PLANNING BOARD REPORT PORTLAND, MAINE

West Port Lofts, 8-unit Condominium Development
22-28 Tate Street
Level III Site Plan and Subdivision Review
2015-182
Tate Street Partnership, LLC

Submitted to: Portland Planning Board Date: December 10, 2015 Public Hearing Date: December 15, 2015	Prepared by: Nell Donaldson, Planner CBLs: 044-E-15, 17, and 19 Project #: 2015-182
--	---

6 FIELD INLET & CRUSHED STONE CHAMBER SECTION
NOT TO SCALE

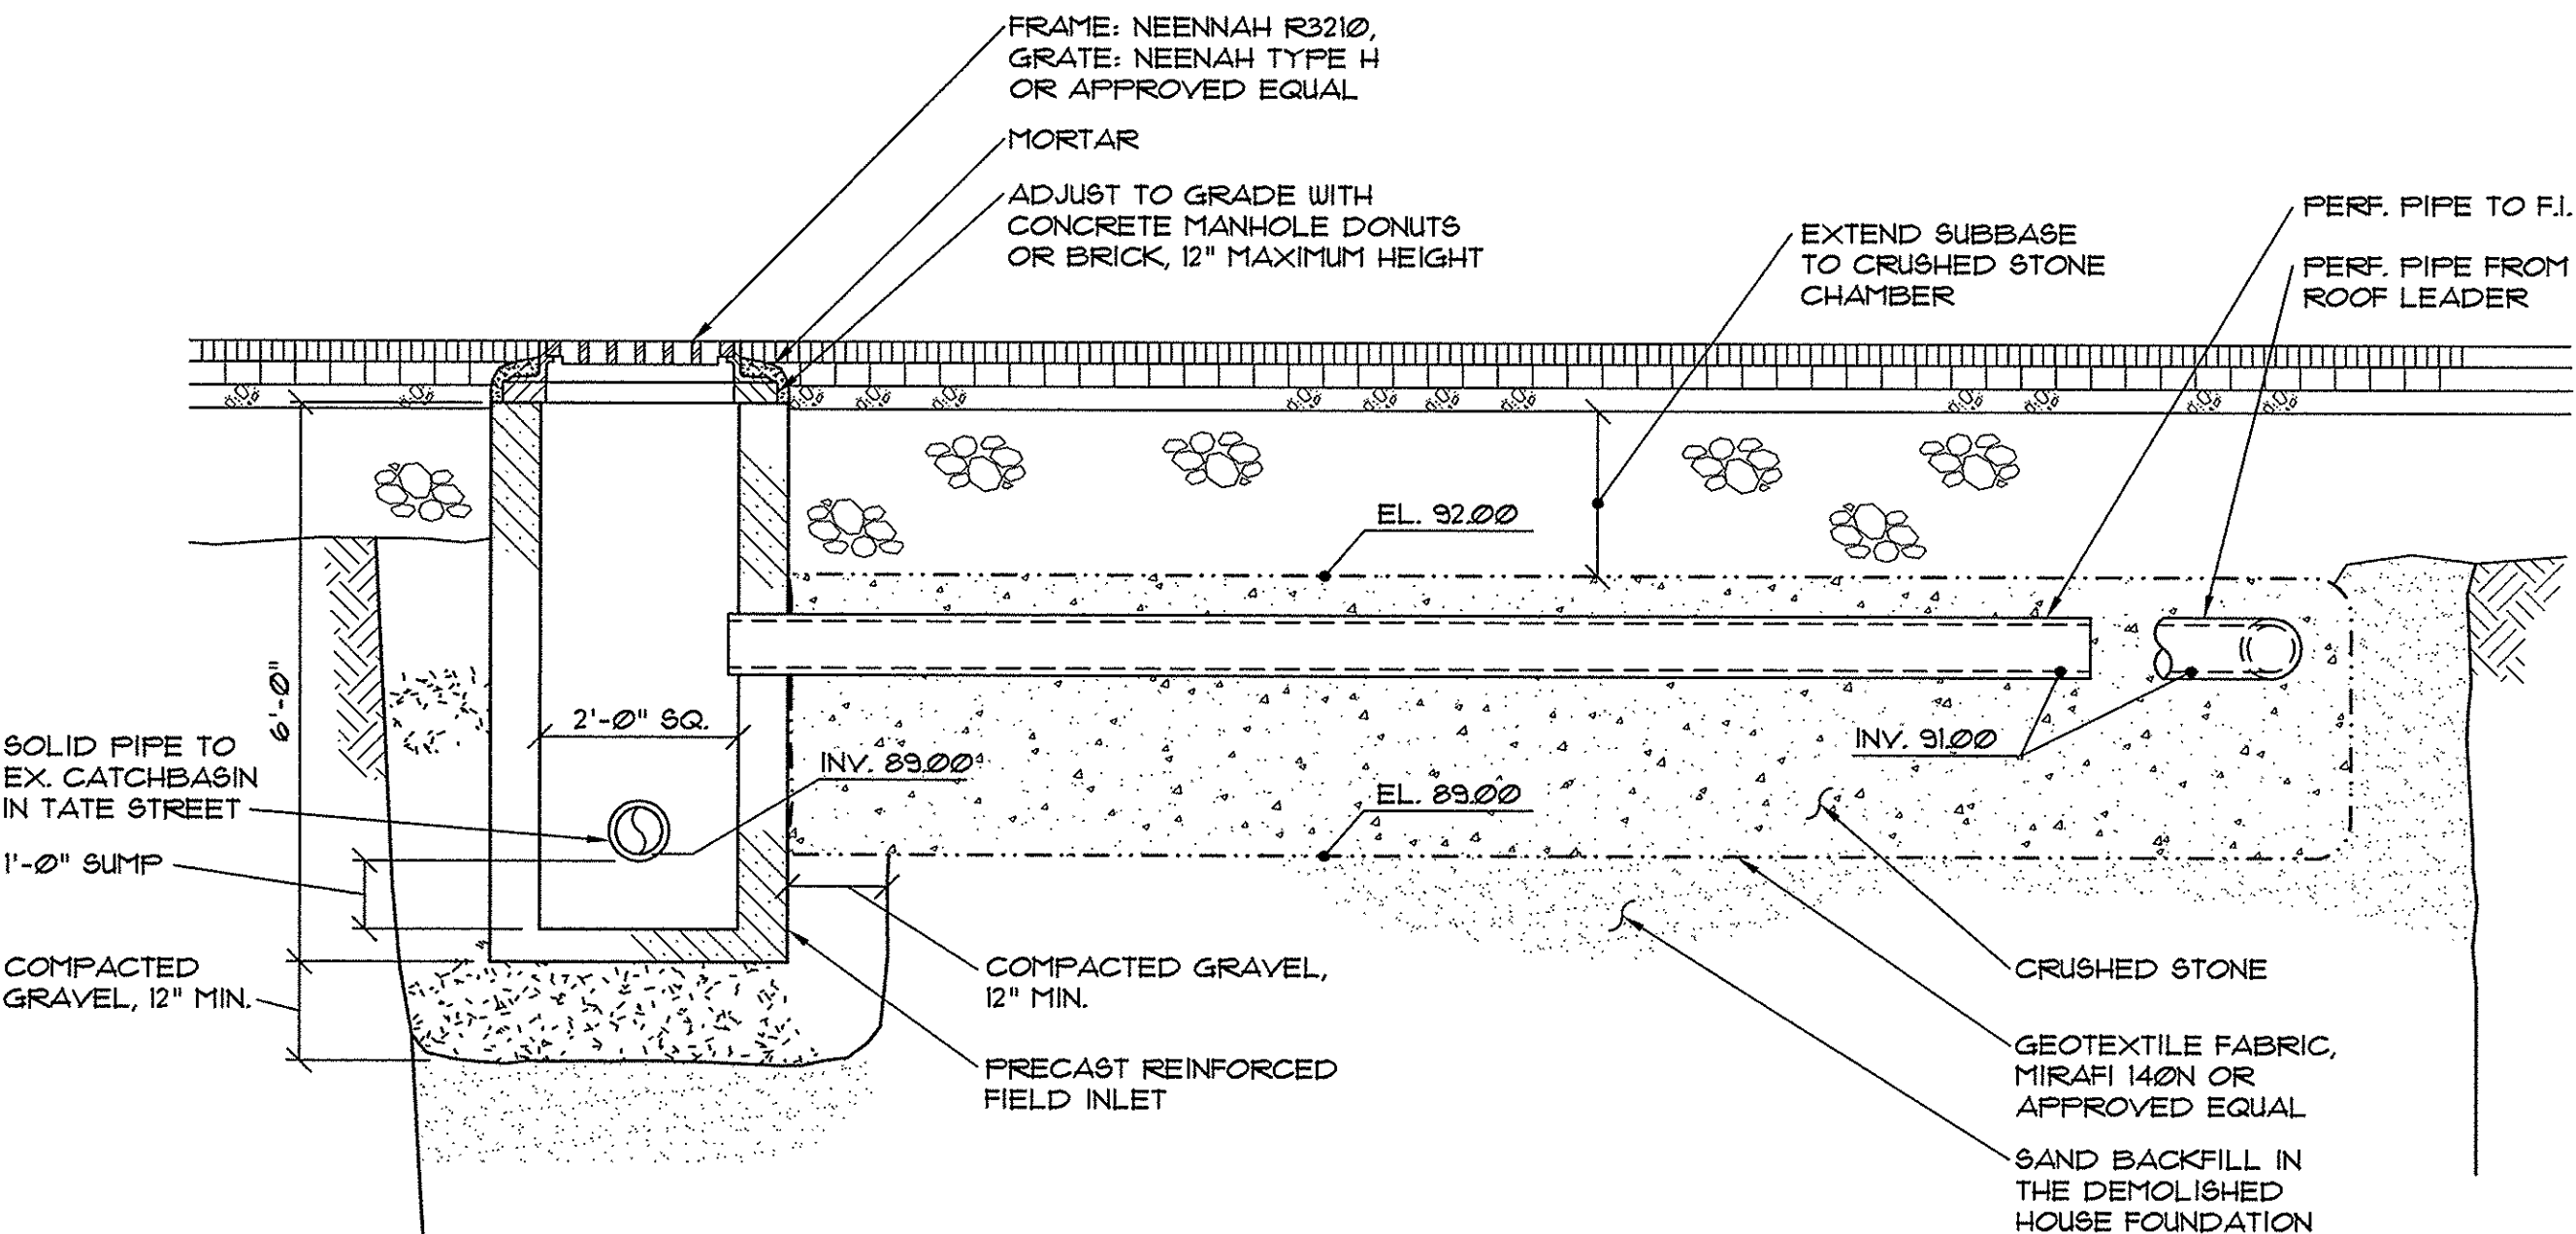
5. It is desirable to have a three foot sump in the proposed catchbasin/field inlet. No dimension is show from bottom of sump to the 6" pipe invert out. Please indicate.
Detail 6 on Sheet C2.2 shows a one foot sump in the applicant's precast field drain structure. The City of Portland Technical Manual requires three foot sumps to all structures discharging to the City's collection system. Please revise detail to show a three foot sump.

5. *It is desirable to have a three foot sump in the proposed catchbasin/tield inlet. No dimension is show from bottom of sump to the 6" pipe invert out. Please indicate. Detail 6 on Sheet C2.2 shows a one foot sump in the applicant's precast field drain structure. The City of Portland Technical Manual requires three foot sumps to all structures discharging to the City's collection system. Please revise detail to show a three foot sump.*

Noted on Sheet C1.3, Standard City Note in Section 7, C2.2 revised.

1 EAST ELEVATION
1/4" = 1'-0"

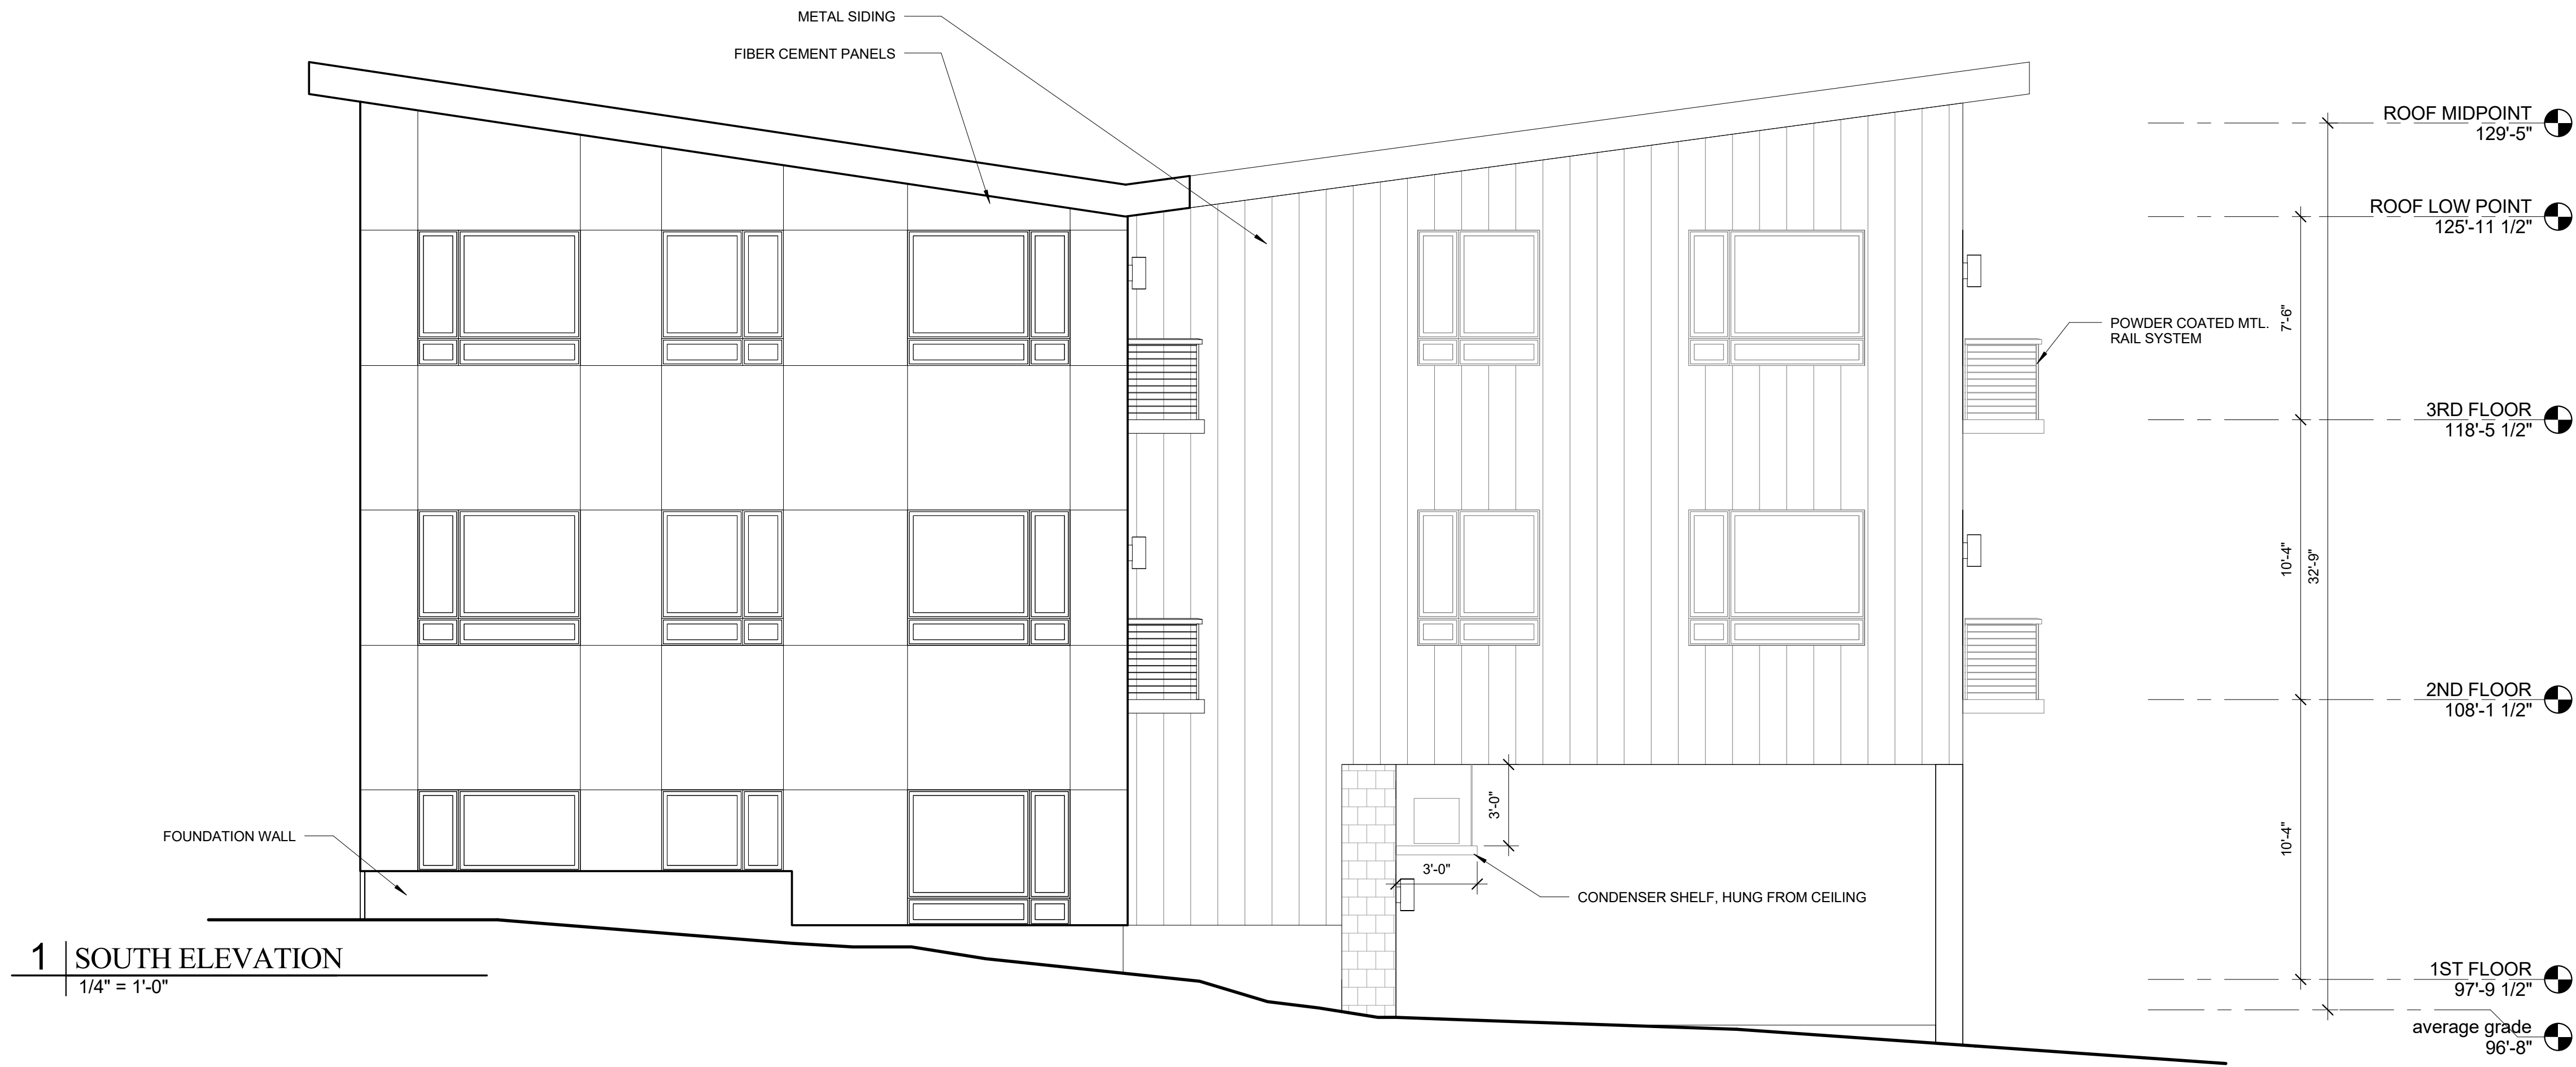
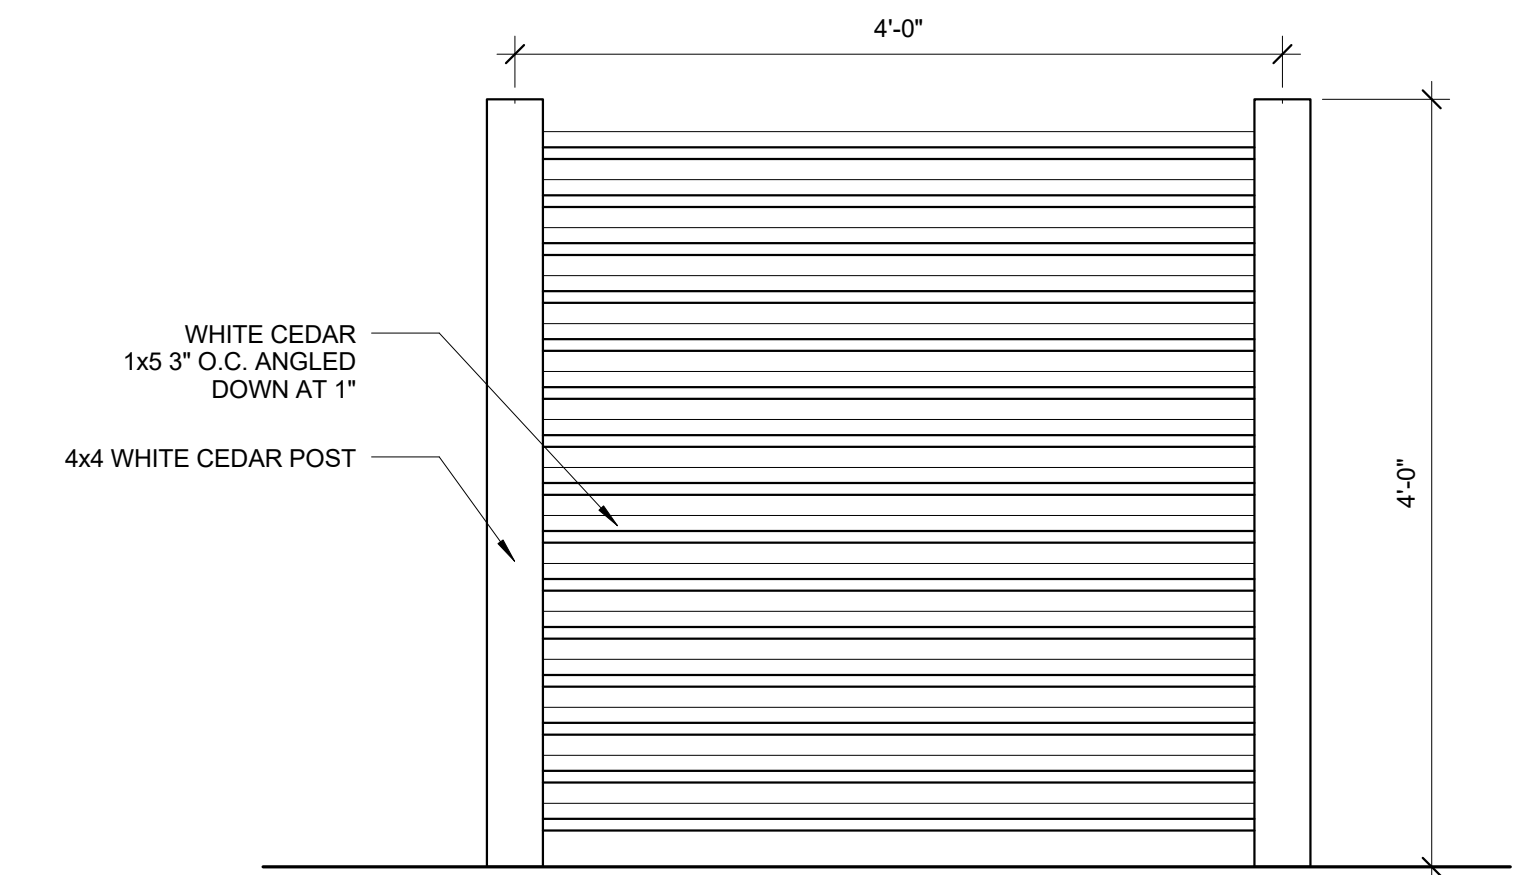
Staff conducted a zoning analysis which found that the project meets the requirements of the R-6 zone, including minimum lot area per dwelling unit, setbacks, lot coverage, and building height. The elevations show the height, based on average grade, at 32’ 9” (*Plan 14*). The R-6 permits 45’ in height.

STONE INFILTRATION TRENCH

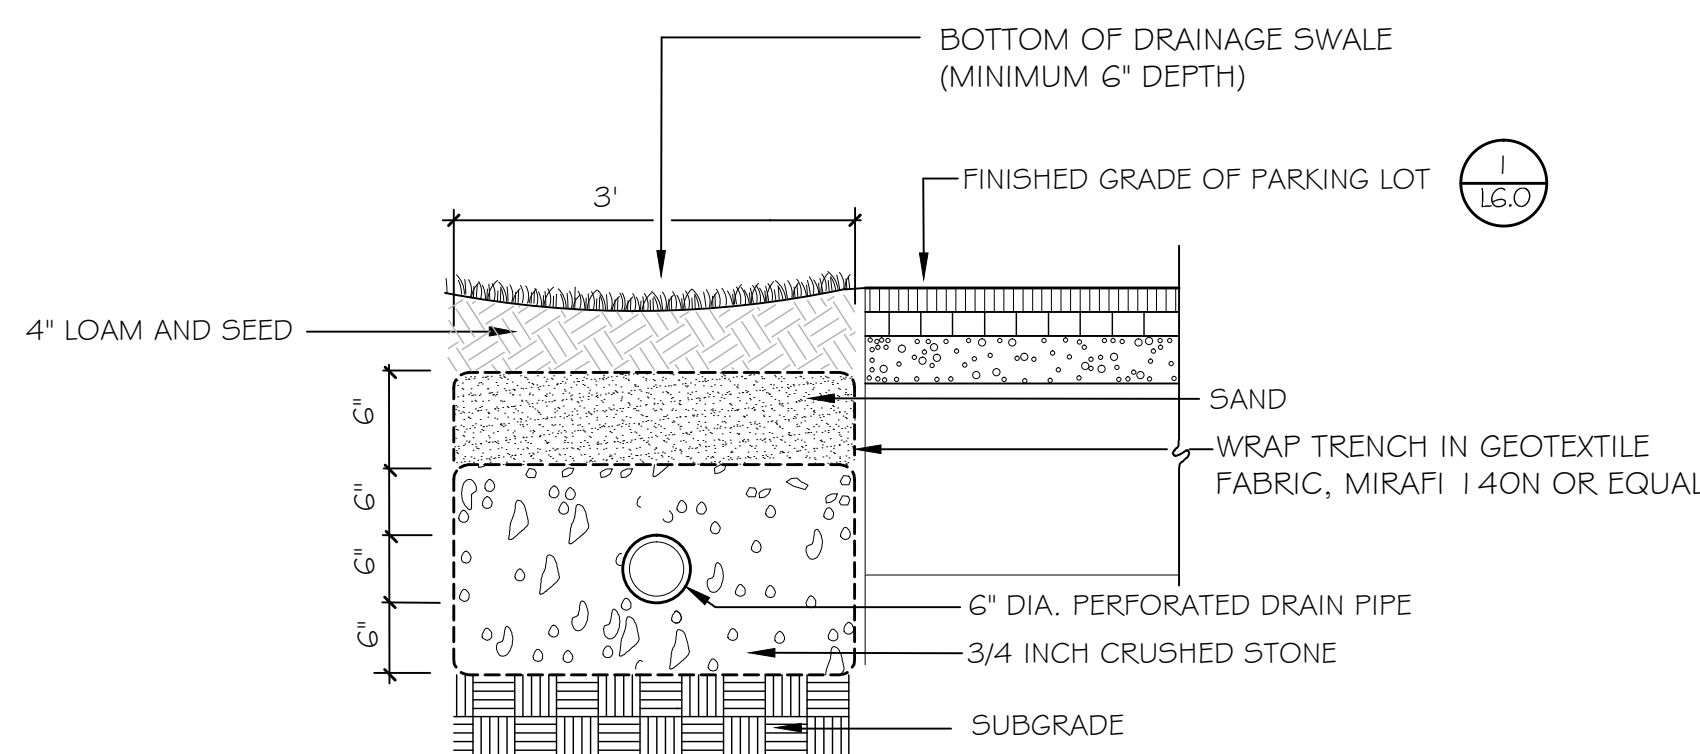
- 2) The Stone Infiltration Trench detail on L6.2 indicates a 4" loam & seed surface with 6" of wrapped sand above a wrapped crushed stone underdrain layer. This detail is acceptable, as it provides an alternative
